Re: **Fourth Submission Review – Porteos** (Infrastructure CSP)
Application Number: **DA-1903-13**
Case Number: **2019-6032-00**

Fourth Submission Review

PORTEOS - PHASE 5 INFRASTRUCTURE SITE PLAN POWATHON ROAD & E. 64TH AVENUE RIGHT-OF-WAY & EASEMENT EXHIBIT	SCALE: AS SHOWN	DRAWN BY: WSC	CHECKED BY: JFF	FILE NO: 8130249709	DATE: OCTOBER 2019
--	--------------------	------------------	--------------------	------------------------	-----------------------

SHEET NUMBER	3
--------------	---

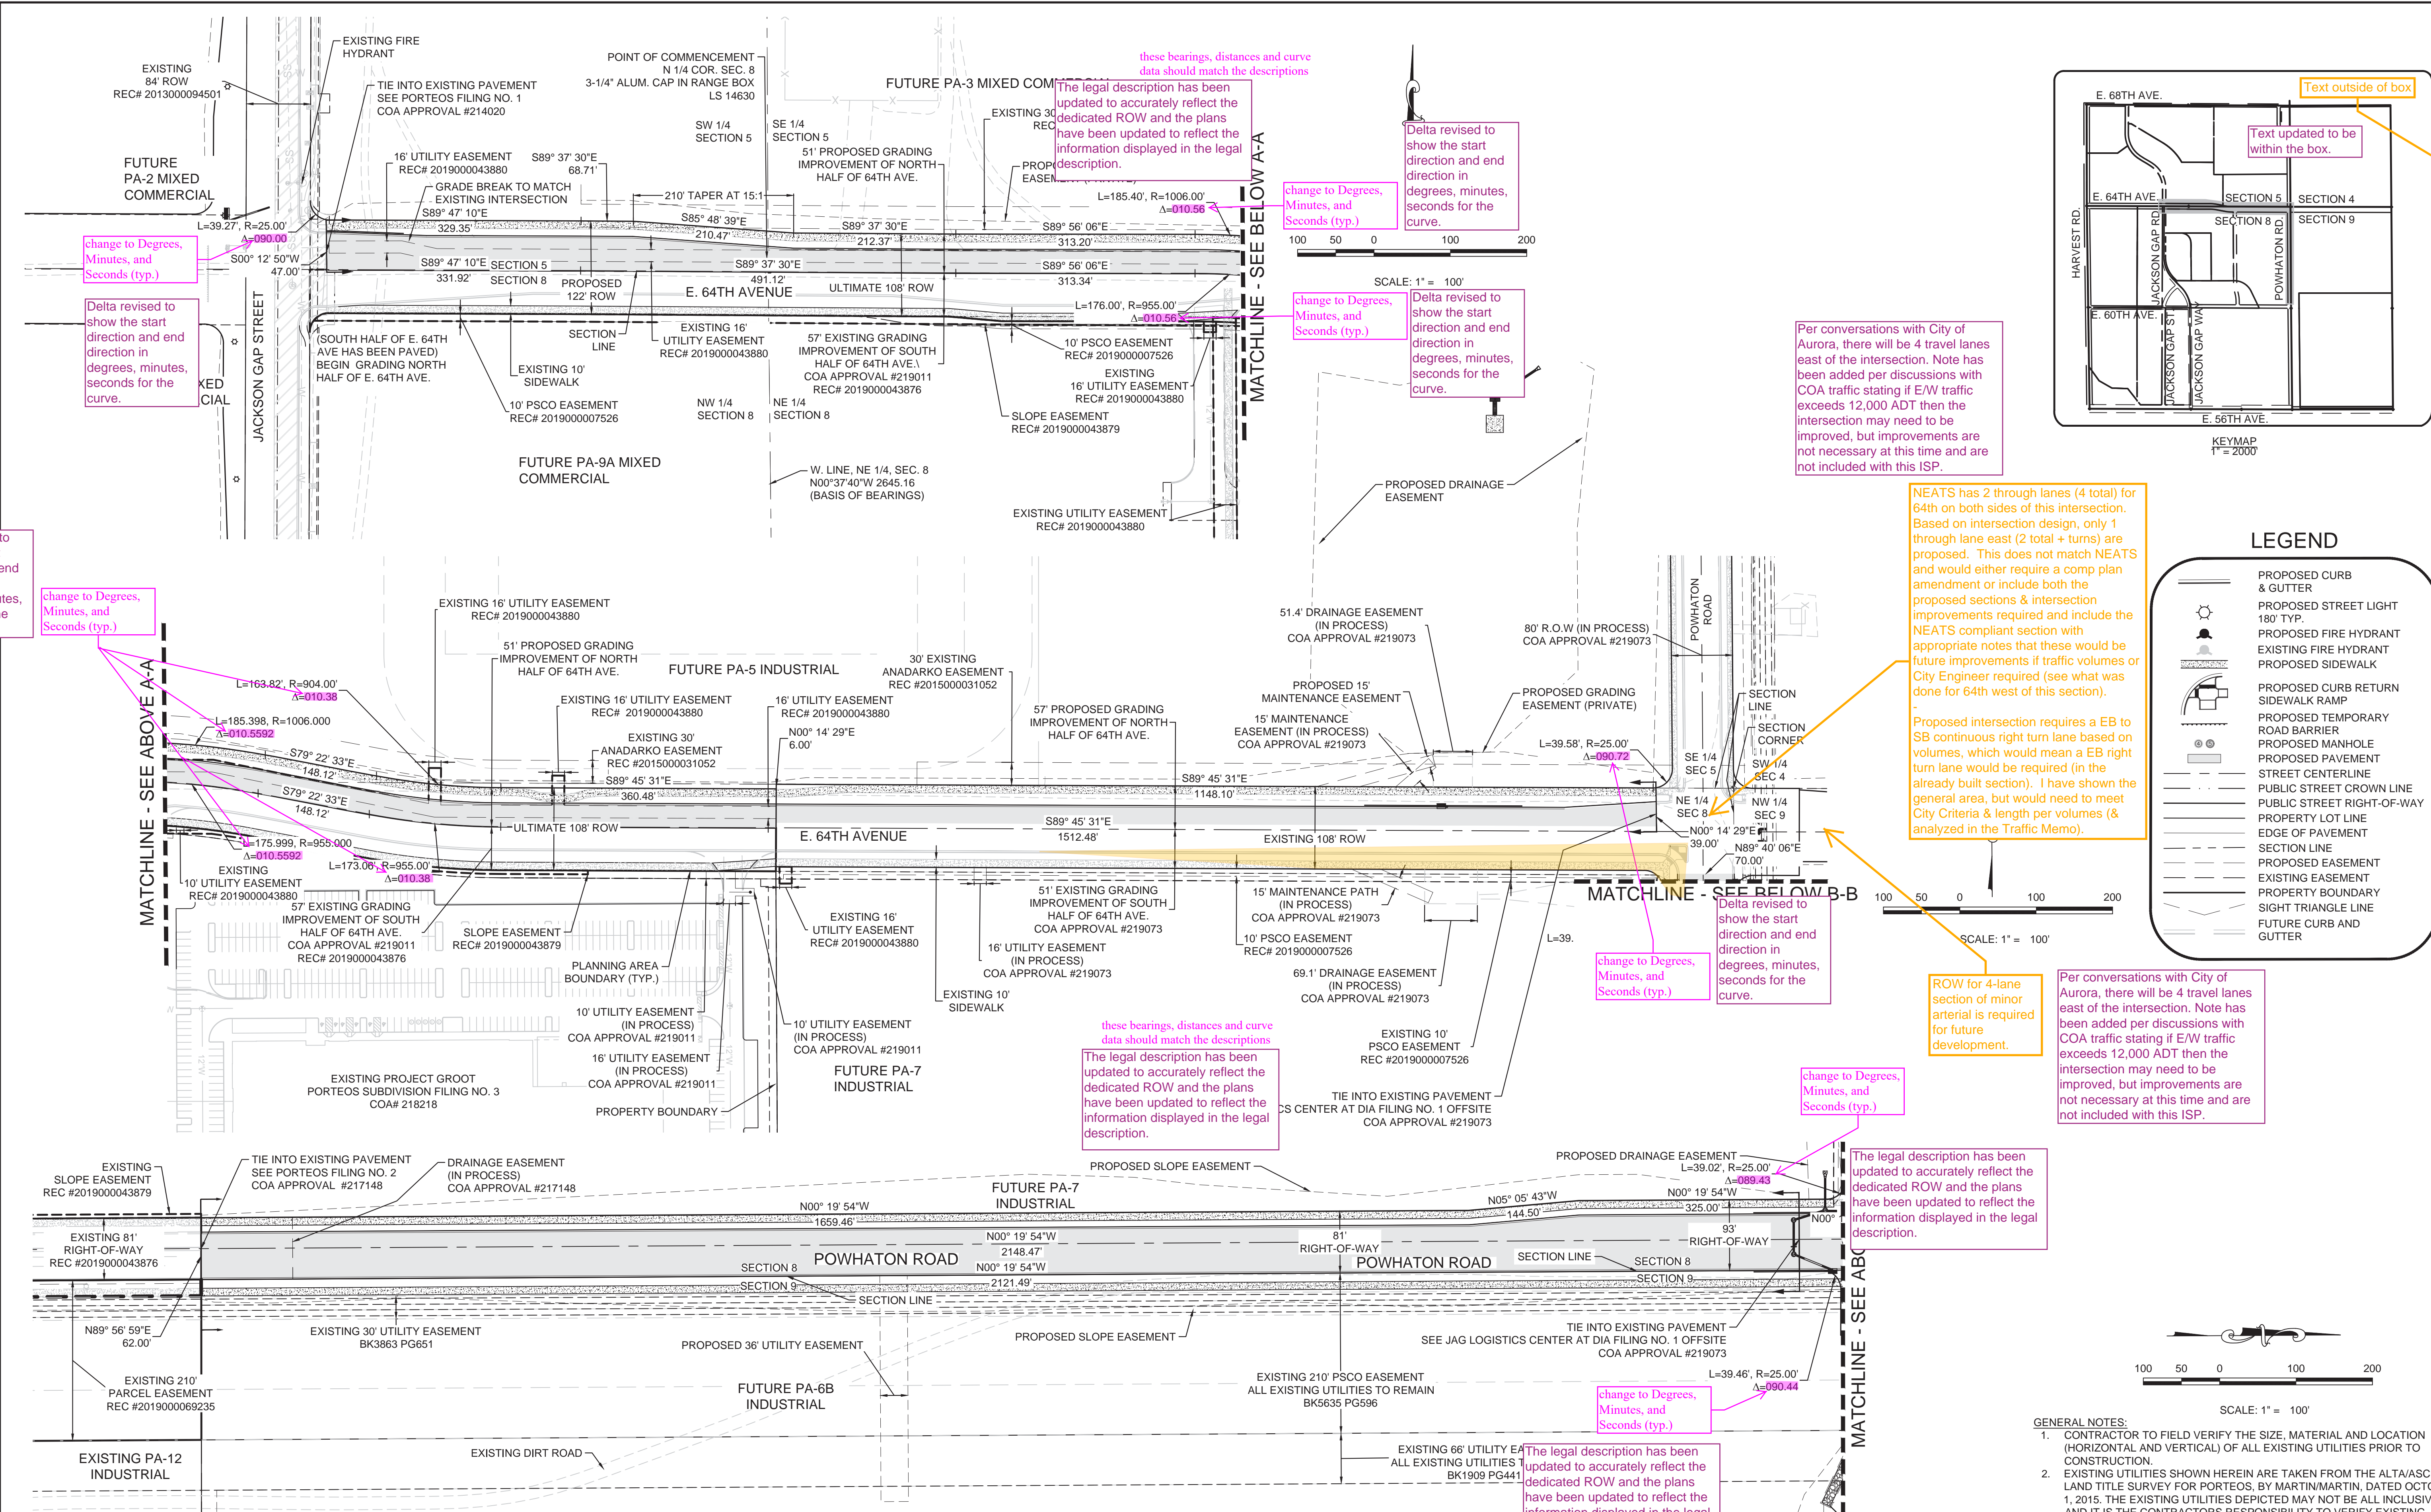
this description is a repeat of the one above - delete the redundant one

The duplicate legal description has been removed and the legal description for the other portion of E. 64th Avenue has been included.

SHEET NUMBER
9

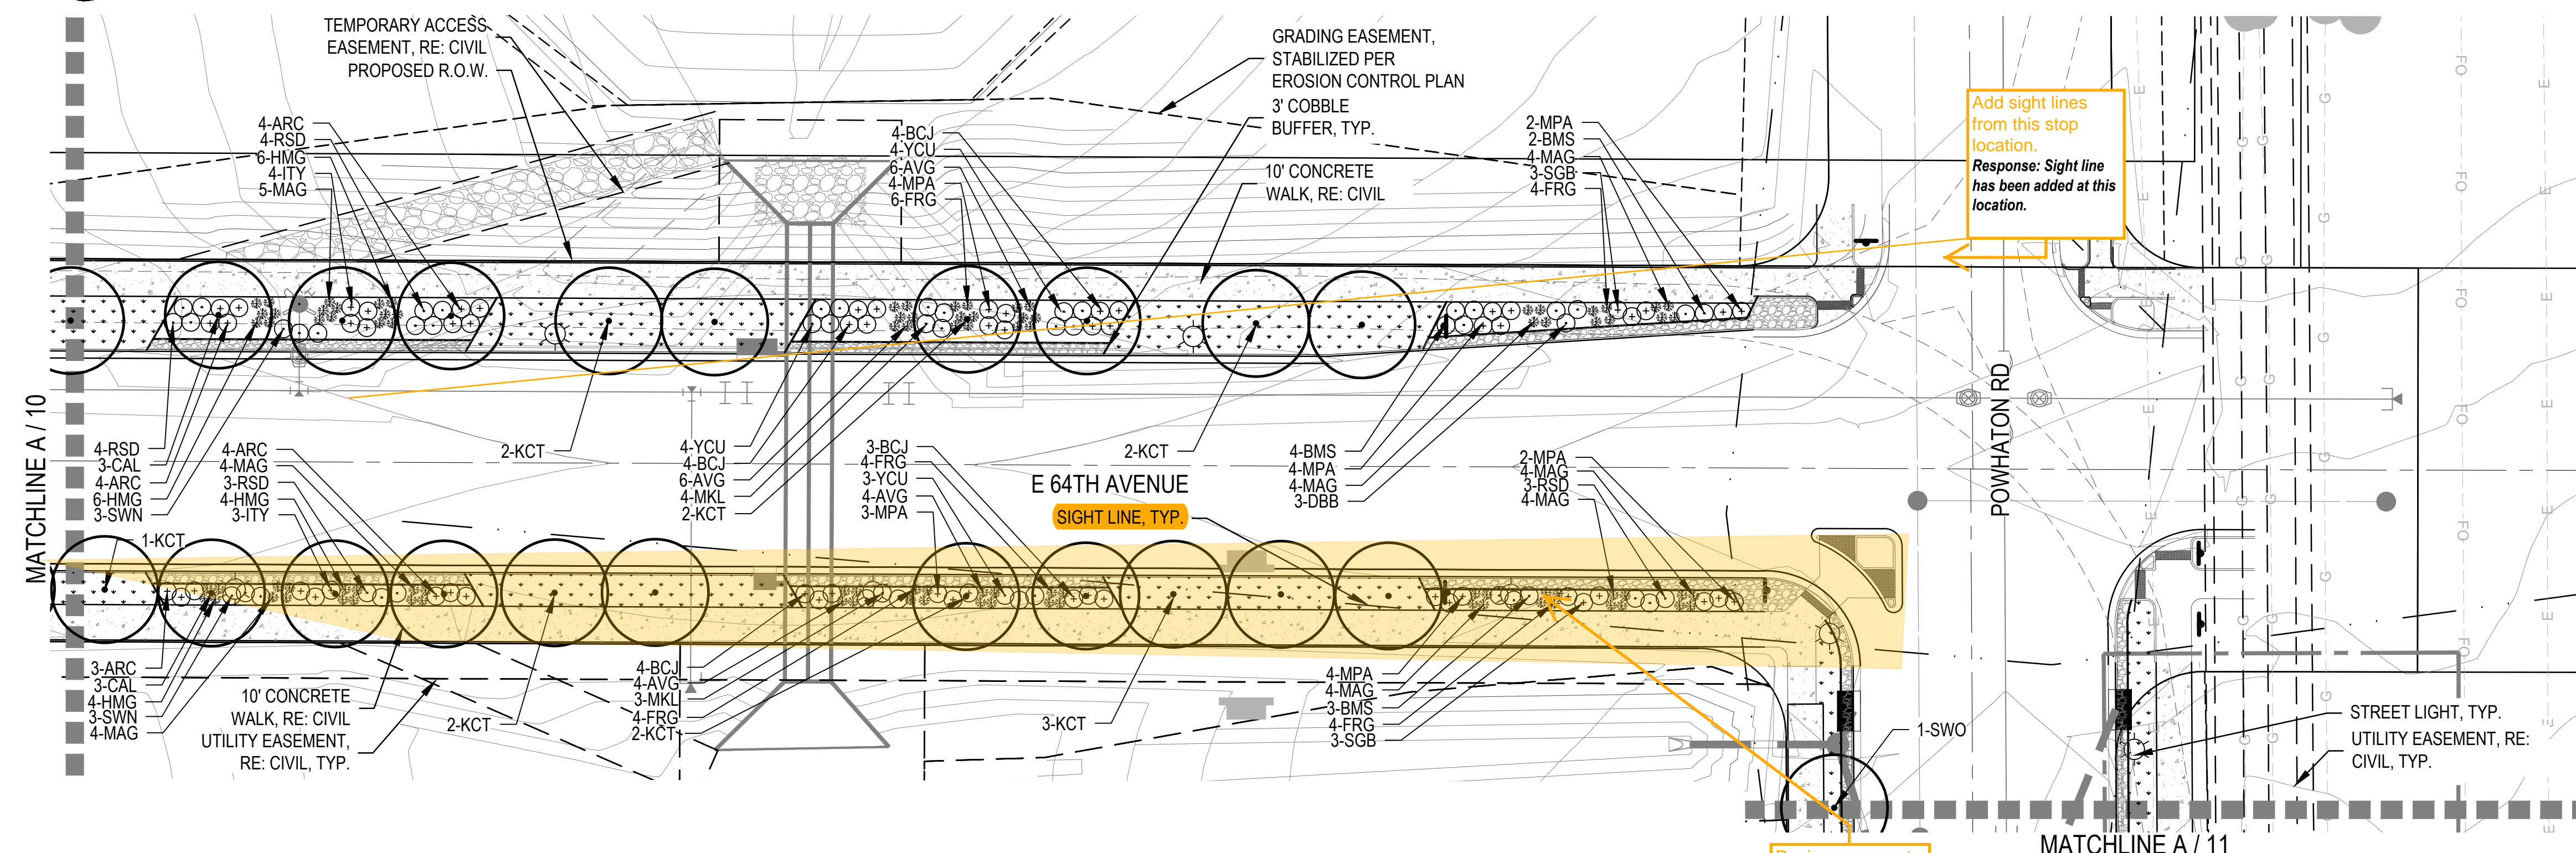
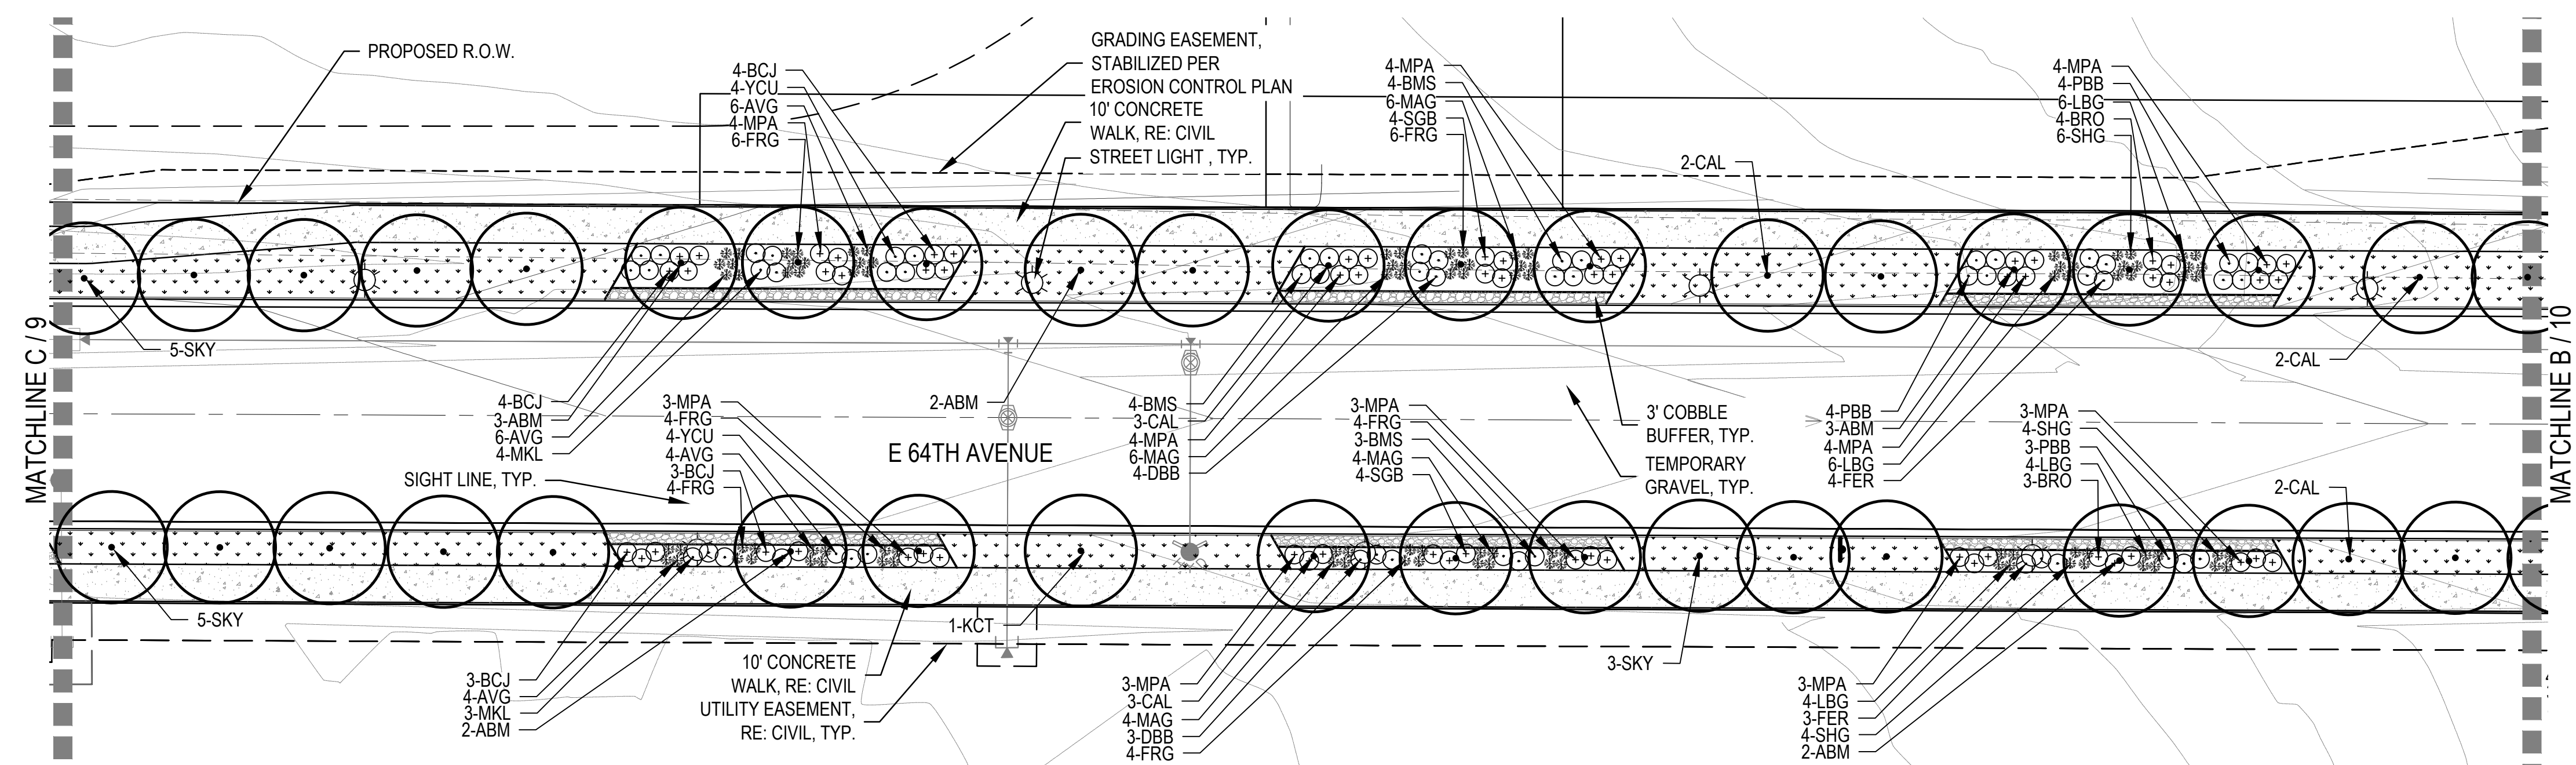
Proposed intersection requires a EB to SB continuous right turn lane based on volumes, which would mean a EB right turn lane would be required (in the already built section). I have shown the general area, but would need to meet City Criteria & length per volumes (& analyzed in the Traffic Memo). Sheet 3

Response: *Per conversations with the city, there will be 4 travel lanes east of the intersection. This corner and section of 64th has not changed.*

Figure I. Year 2040 Traffic Conditions

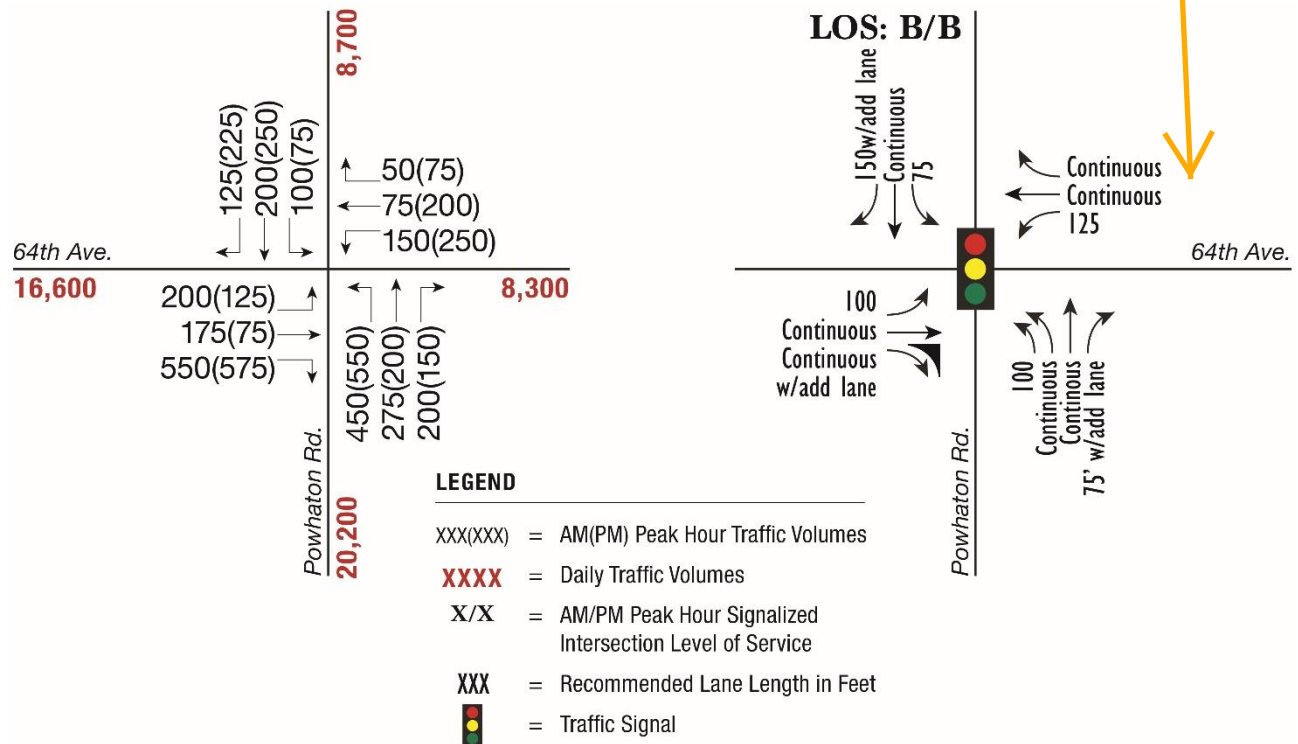
NEATS has 2 through lanes (4 total) for 64th on both sides of this intersection. Based on intersection design, only 1 through lane east (2 total + turns) are proposed. This does not match NEATS and would either require a comp plan amendment or include both the proposed sections & intersection improvements required and include the NEATS compliant section in the ISP with appropriate notes that these would be future improvements if traffic volumes or City Engineer required (see what was done for 64th west of this section).

Response: The updated report shows 64th Avenue as a 4-lane arterial, consistent with NEATS. The intersection need only provide one through lane in each direction.
